E3 Evaluation of the PJM ELCC/ RRS Model

Report Summary Presented to the
Effective Load Carrying Capability Senior Task Force (ELCCSTF)

December 9th, 2025

Figure 4: Daily Peaks of Simulated & Historical Load in Winter

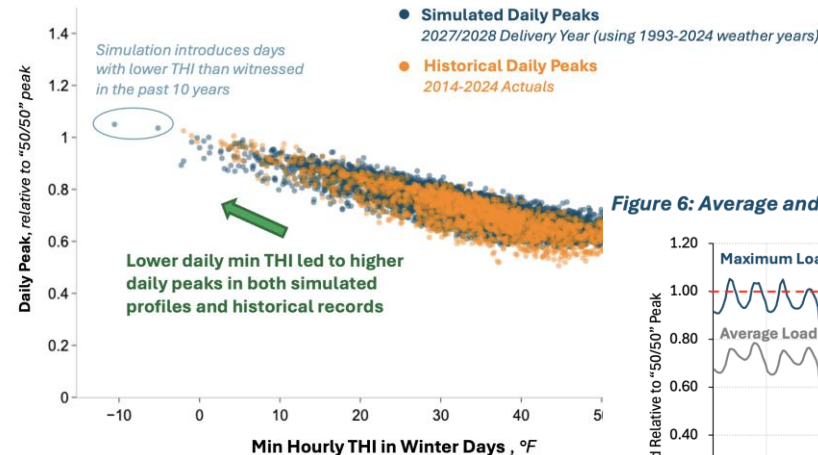
Pros	Cons
<ul style="list-style-type: none"> + Appropriately model wide range of potential weather conditions and load levels + Simulated loads levels in different weather conditions match historical observations + Simulated load shapes match expected seasonal and diurnal load shapes 	<ul style="list-style-type: none"> + 13 load rotations may result in six of the seven days of the week being simulated twice for a given historical weather day, and one day of the week simulated once

Figure 7: Historical Forced Outage Record of Unlimited Resources

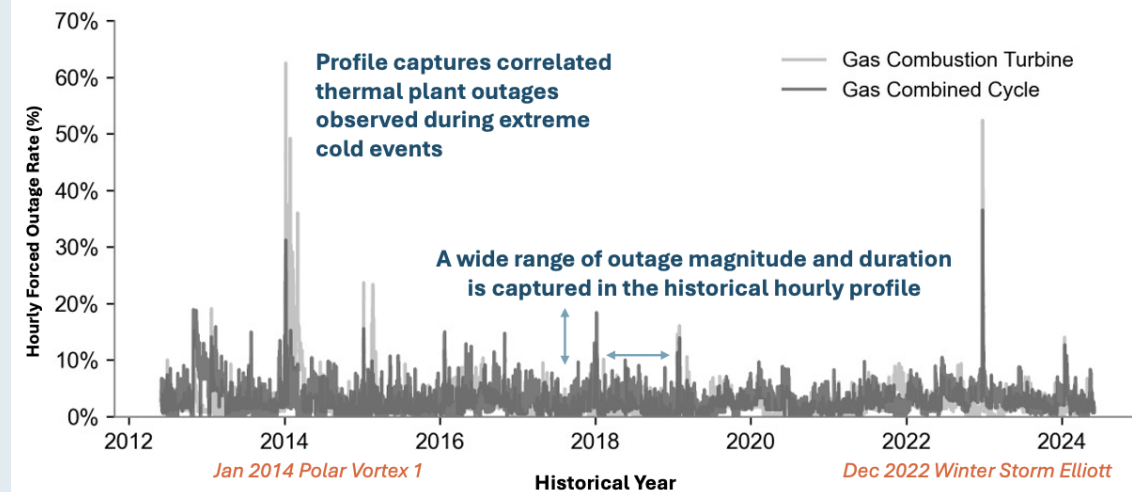
Pros	Cons
<ul style="list-style-type: none"> + Simulates a diverse range of aggregate dispatchable performance, including periods of higher-than-normal outage conditions for unlimited and variable resources + Captures correlated outage events for unlimited and variable resources that are driven by common mode issues to the extent that these events are included in historical data 	<ul style="list-style-type: none"> + Static assumption of battery storage forced outages does not capture periods of higher-than-average forced outages and is inconsistent representation of unlimited and variable resources

Figure 8: Weekly Average Maintenance and Planned Outages for 1993 Weather

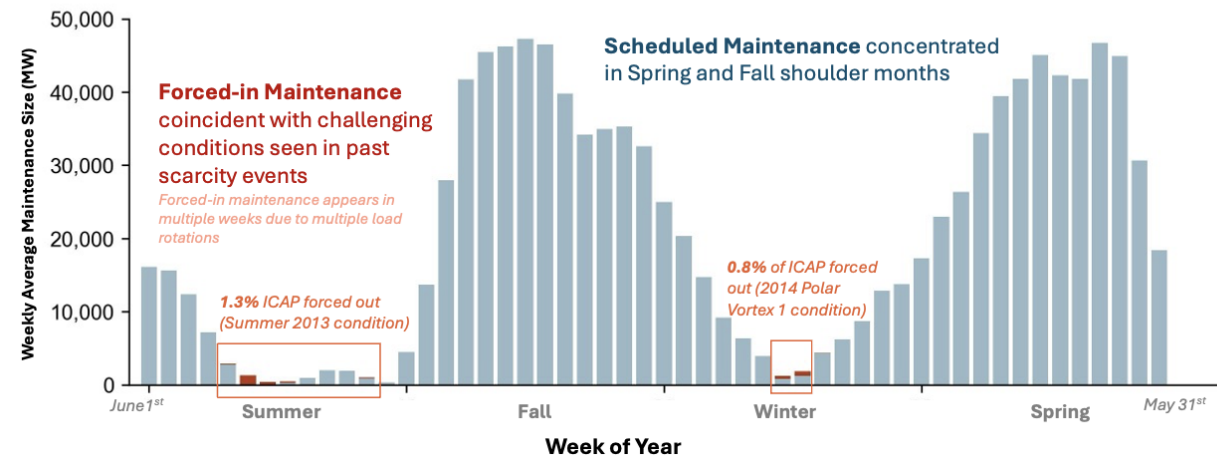
Pros	Cons
<ul style="list-style-type: none"> + Reflects expected real-world planned and maintenance outages by 1) smartly scheduling outages into periods of lowest risk and 2) recognizing that imperfect foresight will yield some minimum level of resources on maintenance during scarcity events 	<ul style="list-style-type: none"> + Use of gross load to define risk periods does not fully align with evolving risk patterns as variable and energy storage resource penetrations increase (although gross load is used to some degree in PJM operational practices)

Figure 9: Thermal Resource Capability Limited at ICAP

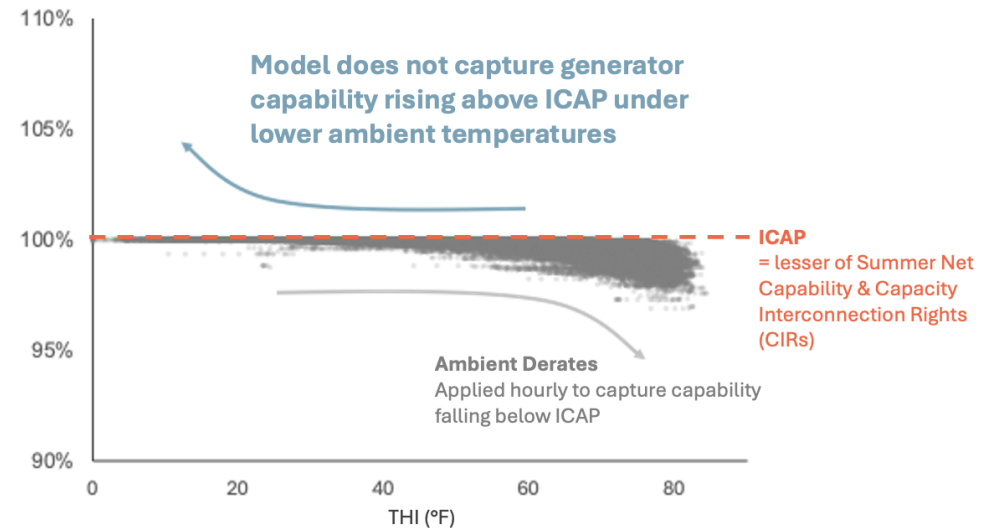
Pros	Cons
<ul style="list-style-type: none">+ Ambient derates are applied to adjust resource capability when temperatures rise+ Network constraints are incorporated through deliverability limitations	<ul style="list-style-type: none">+ Generator capability is limited to potential capacity output in ambient summer peak conditions

Figure 18: PJM 2027/28 BRA Simulated LOLE results by Load Rotation Scenario

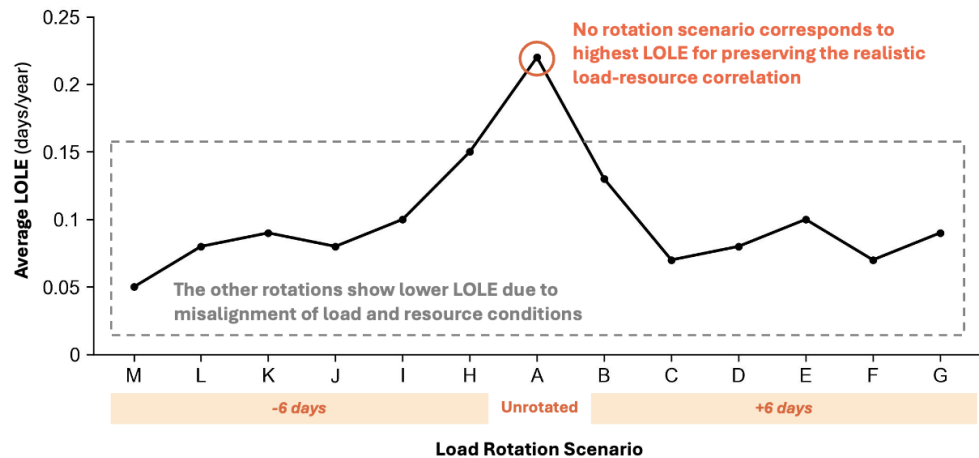
- + The current PJM modeling approach samples resource performance values for each day from the weather bin associated with that particular date, even when rotates different weather through that day

- + This leads to **misalignment between the weather conditions** reflected in the load profile and the weather conditions reflected in the resource performance assumptions, leading to over-stating system reliability

- + PJM could instead consider drawing resource performance values **from the same weather bin that was used to synthesize the load** on each day to more accurately capture the correlation between temperature, load, and resource performance

Consideration 4: Use more temporal granularity to model capability and deliverability of unlimited resources

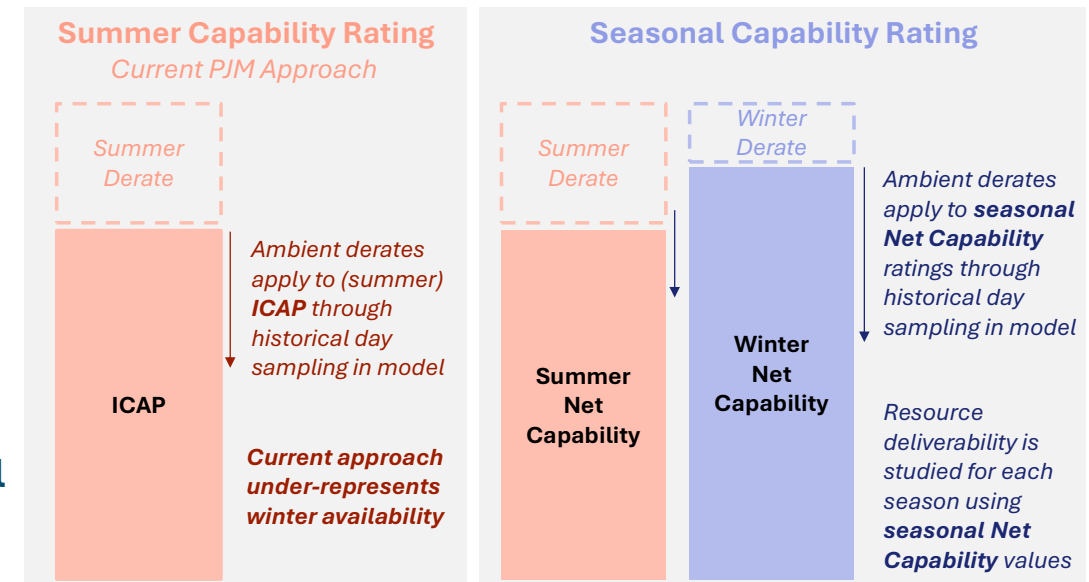
- + PJM currently limits the availability of “unlimited” resources to their ICAP rating in all hours, with additional de-rates applied based on ambient conditions
- + However, unlimited resources generally have higher availability outside of summer peak conditions due to colder ambient temperatures. Capping resource availability at ICAP therefore under-represents the availability of unlimited resources in periods outside of summer peak conditions
- + PJM could consider representing availability with more temporal granularity, specifically on a “seasonal” or “daily” basis

Accuracy	Reflects resource capability changing with temperature conditions, increasing model accuracy
Objectivity	N/A
Stability	N/A
Transparency	N/A
Tractability	More granular data increases complexity of model
Impact Level	High impact. Approximately ~8 GW of additional unlimited resource capability in the winter months, ~1% IRM reduction.
Ease of Implementation	Low difficulty to implement a seasonal approach (which PJM has already done) High difficulty to implement daily approach

Consideration 7: Increase the number of load rotations to balance days-of-week

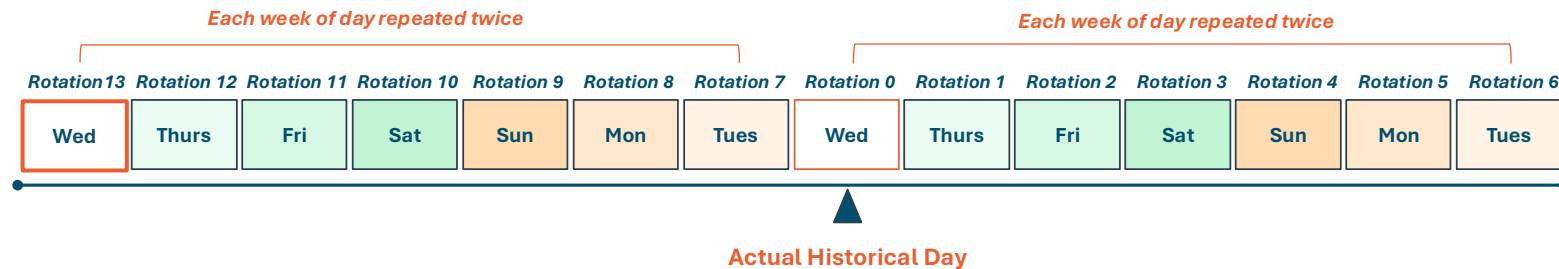
- + PJM currently develops load profiles using 30 years of historical weather data, and additionally “rotates” the weather forward and backward by 6 calendar days for a total of 13 load rotations
- + An issue with PJM’s approach is that rotating weather 6 days forward and 6 days backward means that each day of the week is represented twice **except for the actual day of week for the historical date**
- + PJM could consider **increasing the number of weather rotations to 7** calendar days forward and **6** calendar days backward for a total of 14 weather rotations, so that each day of week is represented twice
 - Any adjustments to number of load rotations would need to remain consistent with the Load Forecast team

Consideration 7: Increase the number of load rotations to balance days-of-week	
Accuracy	Improved accuracy due to uniformly sampling the days of the week
Objectivity	N/A
Stability	N/A
Transparency	N/A
Tractability	N/A
Impact Level	Modest impact on reliability statistics and ELCC values
Ease of Implementation	Would require coordination with PJM Load Forecast team to ensure consistency

Figure 20: Consecutive-Day Average Forced Outage Rates Before and After Scrambling

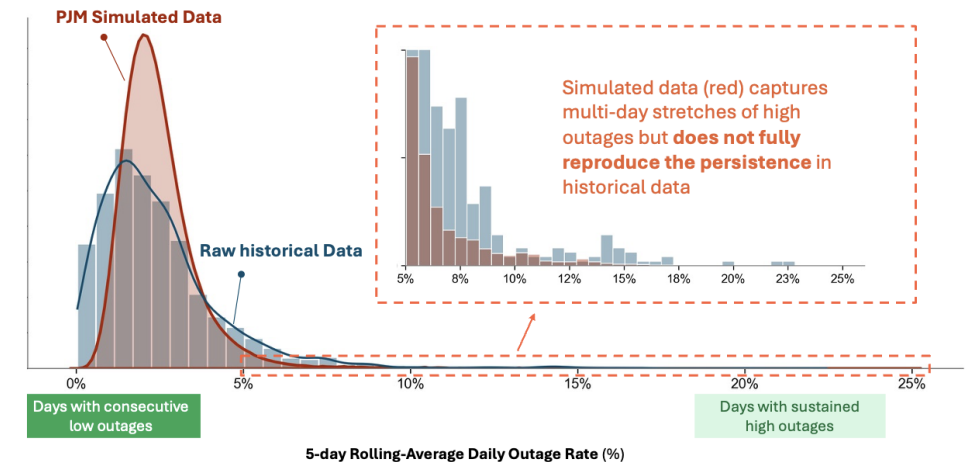
- + PJM's current methodology draws resource performance for each day based on that day's temperature without taking into account the prior day's resource performance
- + While this approach reproduces overall resource performance distributions, it **fails to capture multi-day patterns** where high or low performance tends to persist
 - This may overstate system reliability, especially with higher levels of long-duration storage
- + PJM could consider **studying an approach to capture multi-day resource performance events**, e.g. by introducing the prior day's resource performance as a factor in drawing the resource performance profile for a particular day

Accuracy	Reflecting multi-day resource performance events increases model accuracy and exposes potential reliability risks and resource limitations in some resource portfolios
Objectivity	N/A
Stability	N/A
Transparency	N/A
Tractability	Implementing a persistence factor introduces some additional complexity
Impact Level	The potential impact is likely to be small at present due to limited quantities of long-duration storage. As storage penetrations grow, the impact is likely to become larger
Ease of Implementation	Moderate to high implementation effort. Capturing multi-day events will require study to identify different approaches and the performance and tradeoffs of those approaches
